Subject: Farmstead – Phase H-4 Plat Submittal
Grove City, Franklin County, Ohio
CEC Project 300-327

Date Prepared: 7/24/2024
File Name: Disposition of Comments

FARMSTEAD

SUB AREA H - PHASE 4

PLAT

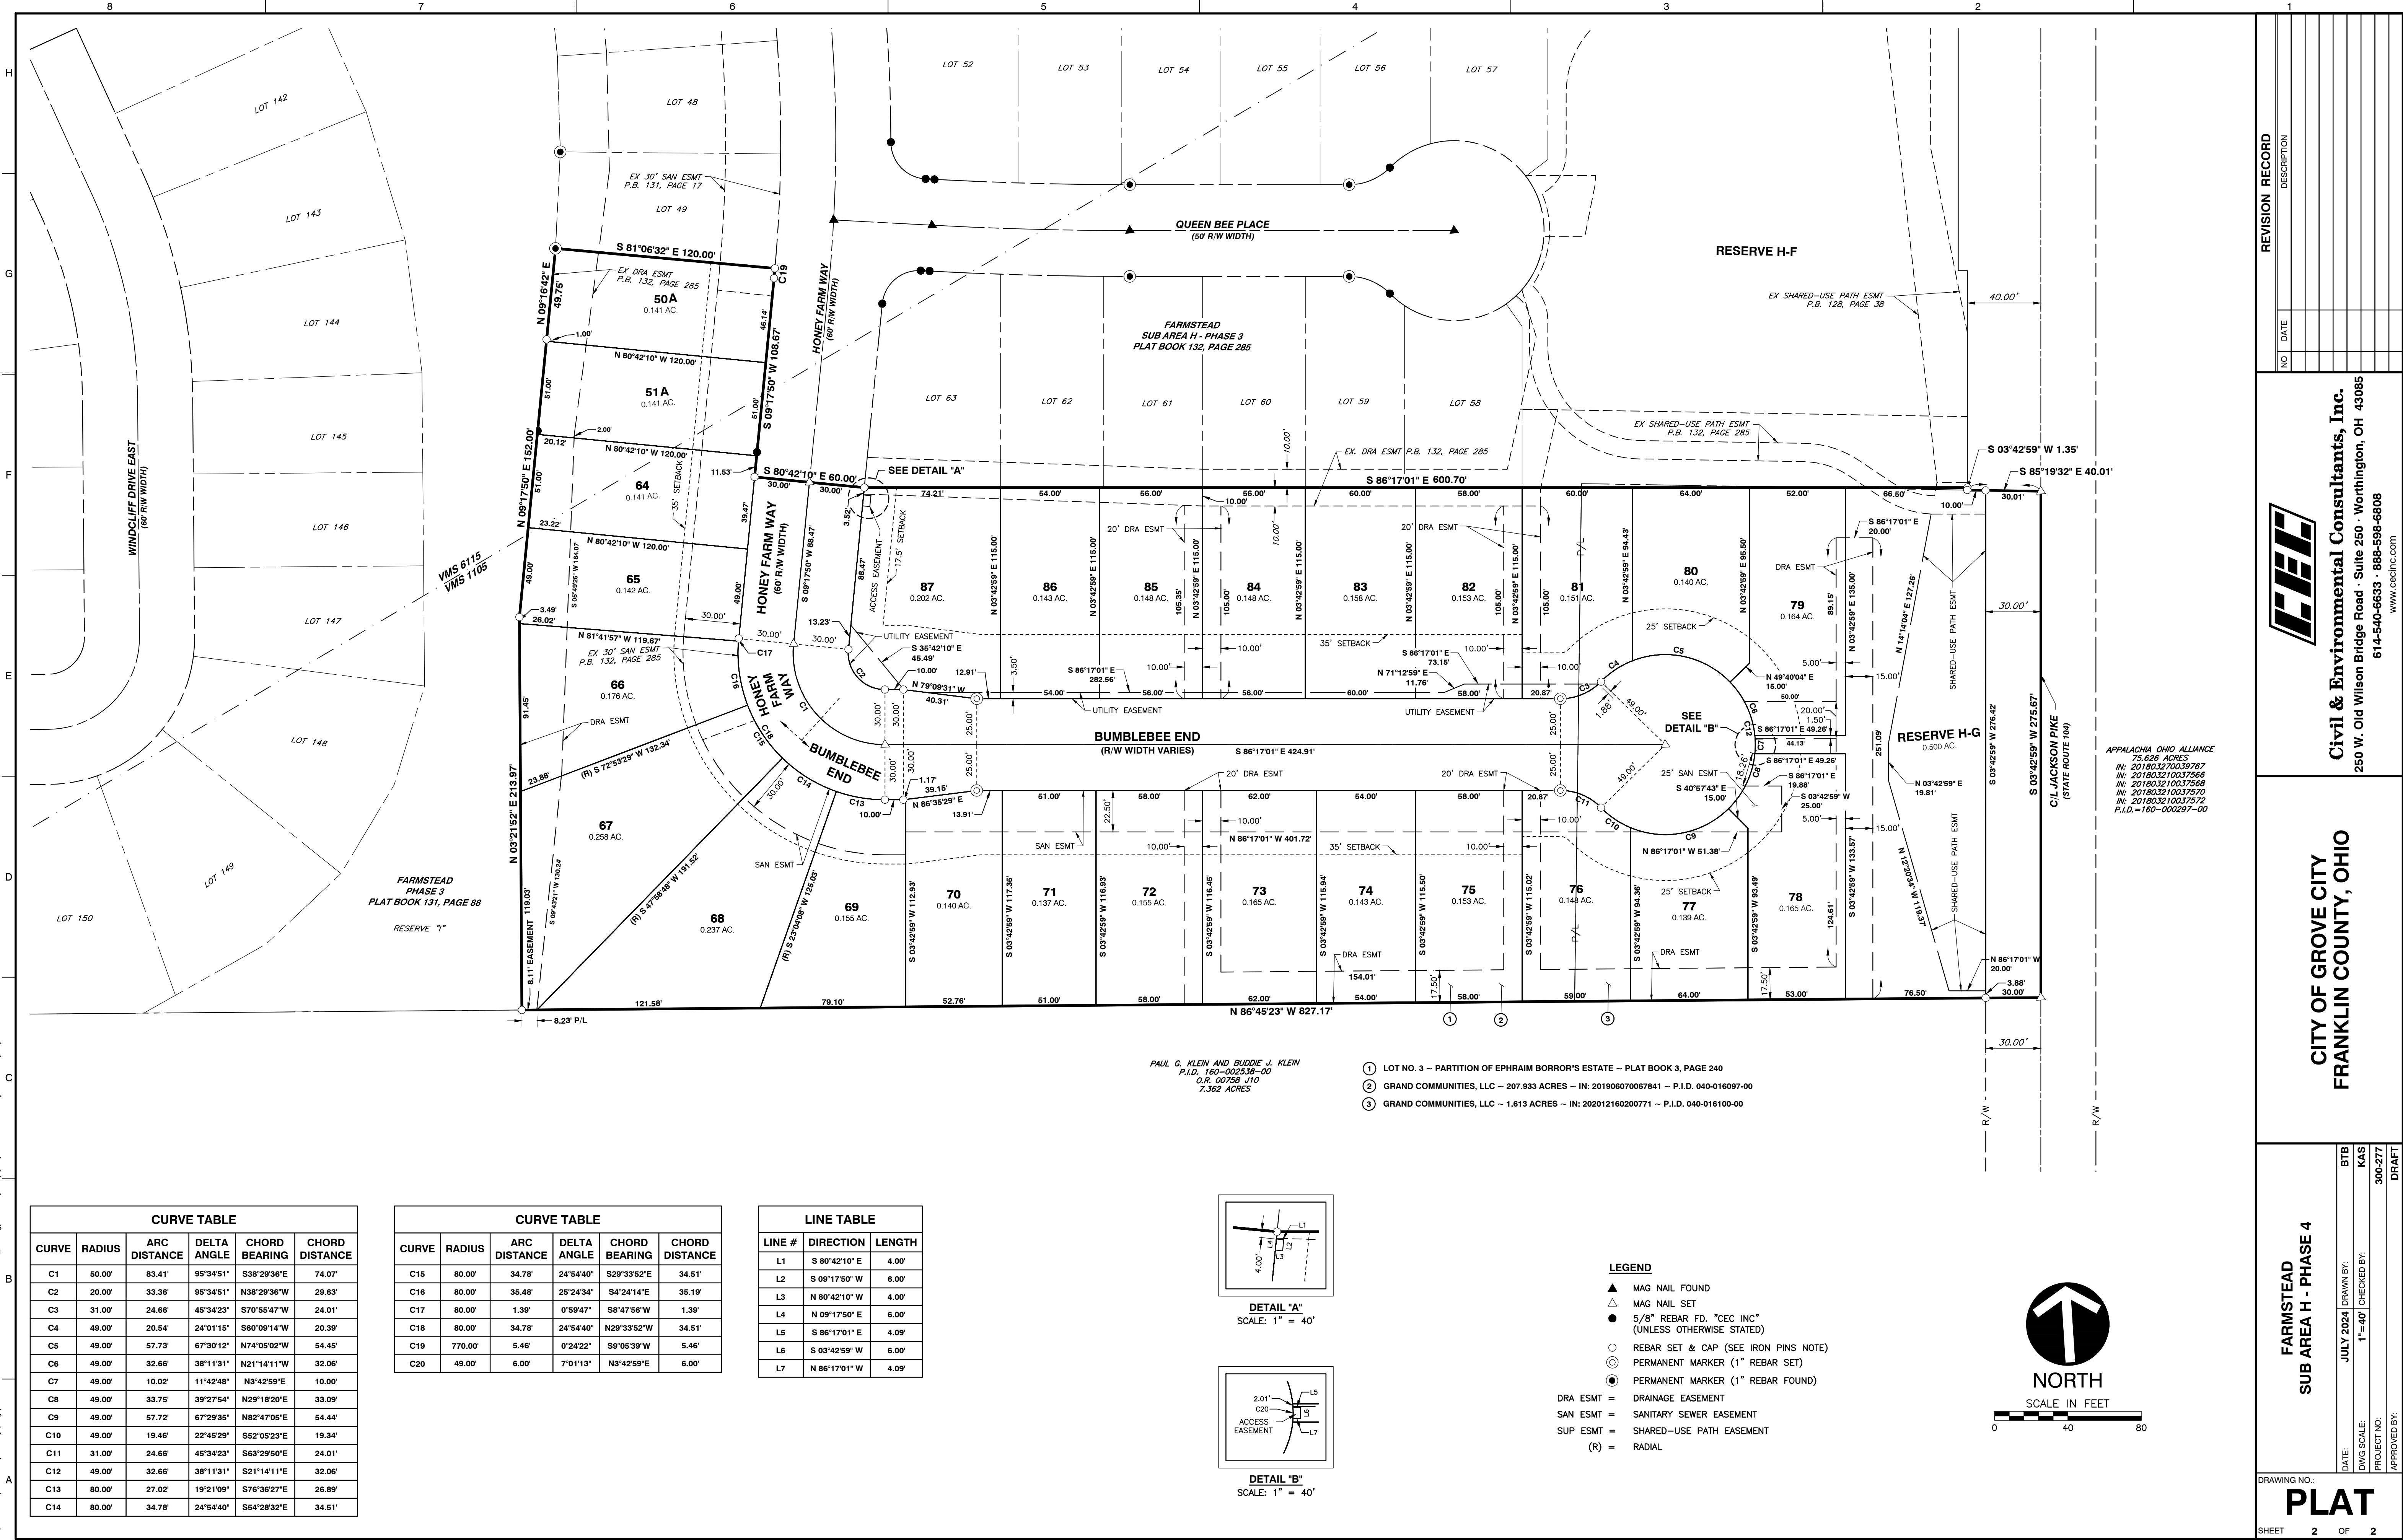
1. Staff has concerns over the language regarding easements on page one. Staff recommends the language be changed to match the note of the Farmstead Sub Area H – Phase 3 Plat for consistency. Language is noted below.

2. Construction plans show an easement along the south side of Lot 79 that is not shown on the plat. Please confirm the discrepancy. Easement has been added to the plat.
3. Remove station information. Street name break should align with the lot line between parcels 67 and 68. Staff recommends showing street names at the break location. Removed station label and added road names at the break point.
4. Remove the property line located towards the eastern section of Bumblebee End. The property line bisecting lots 76 and 81. Property line shown is the property line delineating the line between the existing 1.613 acre parcel and the 207.933 acre parcel.
5. Add labels to the easement in Reserve H-G. Labels have been added to clarify the easements.

The note on the plat as submitted matches the note on the recorded plat of Phase 10. This note started on the Phase 6 plat and was revised and approved per City comments for the Phase 10 plat. Note not revised.
